Subject: TPE331 Propeller Pitch Control Lever

To: Flight Safety @ OEM

Figure 1

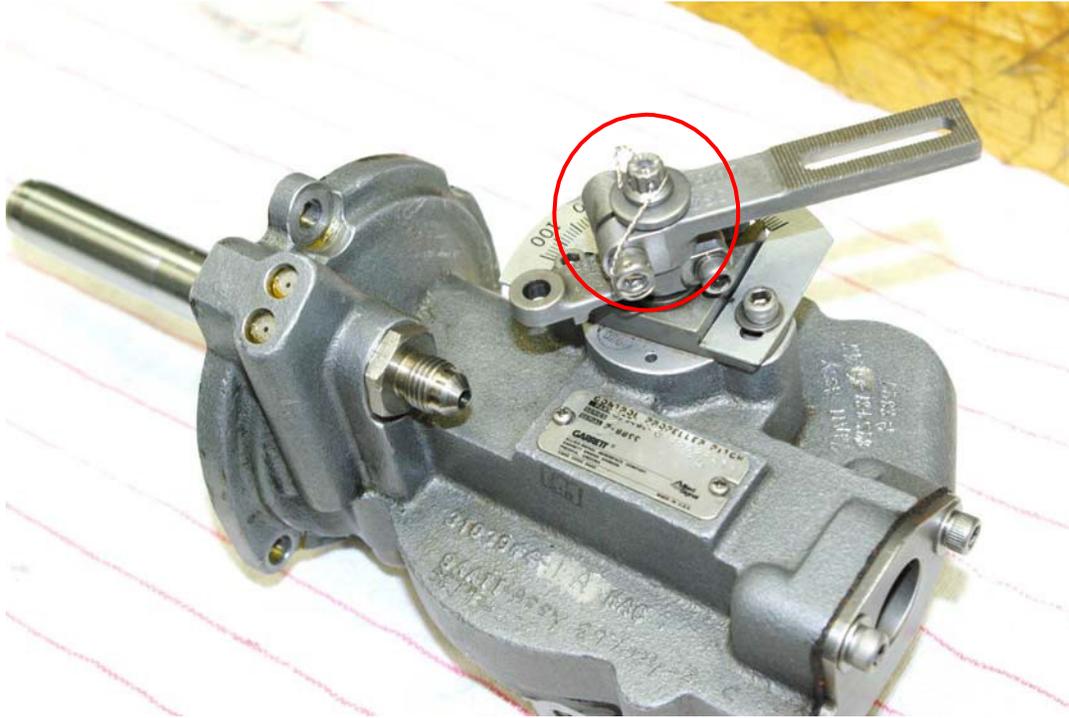
Most of the production PPC cam assemblies currently supplied by Honeywell have a threaded hole in the vertical PPC splined shaft. However, this threaded hole feature is dependent upon when the shafts were manufactured. The threaded hole provides for the installation of a second bolt P/N MS9565-X and washer P/N S9011F23-105 to provide for a secondary feature for retention of the OEM supplied lever. The second bolt head should be safety wired to the lever (see figures 1 and 2).

In view of service experience, Honeywell is recommending that you and other aircraft manufactures consider incorporating the bolt, washer and safety wire as a secondary feature for retention of the OEM supplied lever.
